Subject: Submittal of report "Effect of In-Package Chemistry on the Degradation of Vitrified High-Level Radioactive Waste and Spent Nuclear Fuel Cladding" (CNWRA 2002-01), Intermediate Milestone 01402.571.180

RESPONSES TO NRC COMMENTS ON IM 01402.571.180

“EFFECT OF IN-PACKAGE CHEMISTRY ON THE DEGRADATION OF VITRIFIED HIGH-LEVEL RADIOACTIVE WASTE AND SPENT NUCLEAR FUEL CLADDING”

Figure 2-5. Normalized Leach Rate for Boron Versus Time for WVDP Ref. 6 and DWPF Blend 1 Glasses in Various Solutions at 90 °C

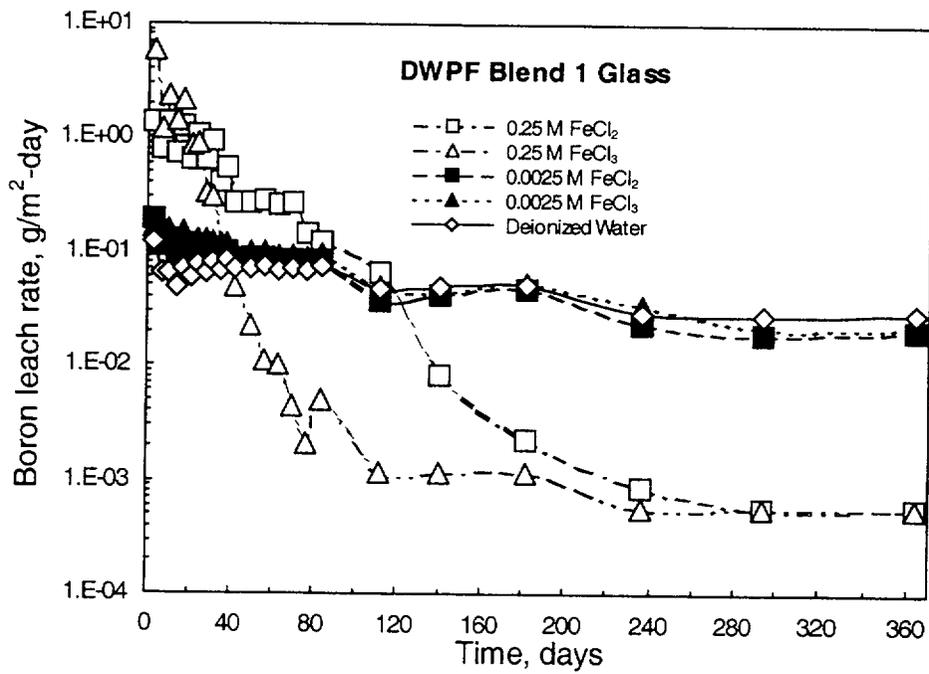
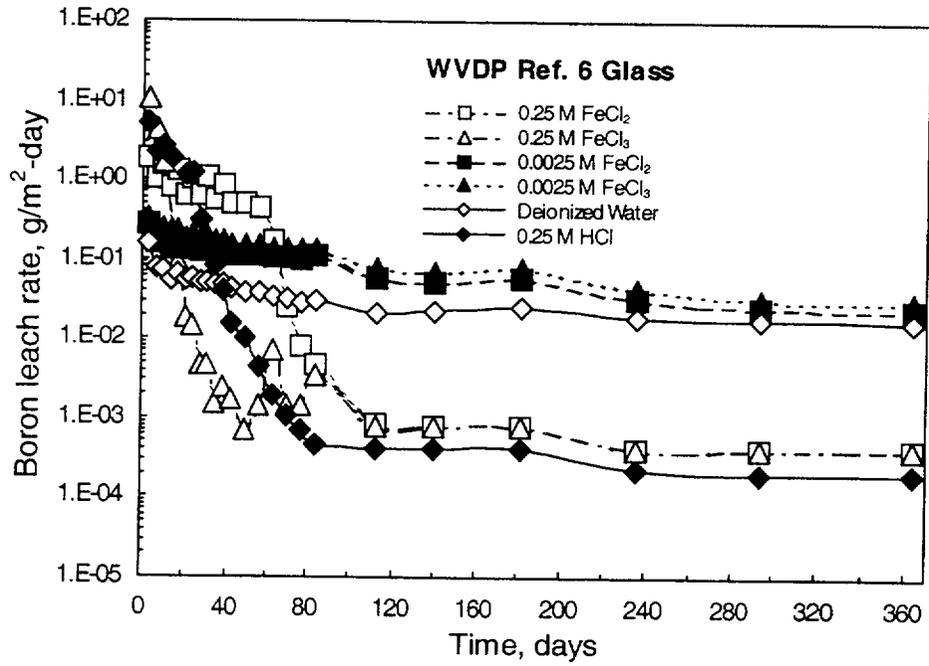
13. **Page 23, 3rd paragraph. "This theory is supported by....in Figure 2-5." Could not find the inductively coupled plasma atomic emission spectrometry analyses results in the figures.**

The boron leach rates plotted in Figure 2-5 are from the inductively coupled plasma atomic emission spectrometry analyses. No change made.

Figure 2-7. Leachate pH Versus Time for WVDP Ref. 6 Glass in Various Solutions at 90 °C (Closed Symbols for the Initial pH and Open Symbols for the Final pH)

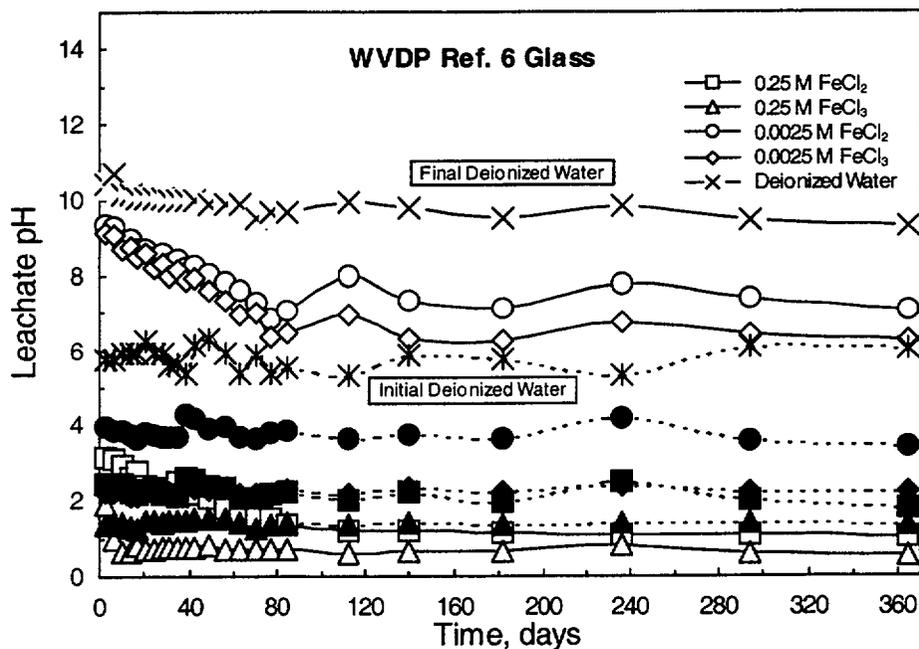
12. **Page 18, 3rd paragraph. "In all cases, except the leachates..." In figure 2-7, it appears (this is a copy and I don't have the data set) that the final pH levels are lower than the initial pH levels.**

From the glass leaching tests, the final pH values of the solutions are generally higher than the initial pH except the high concentration iron chloride solution tests. Text modified.
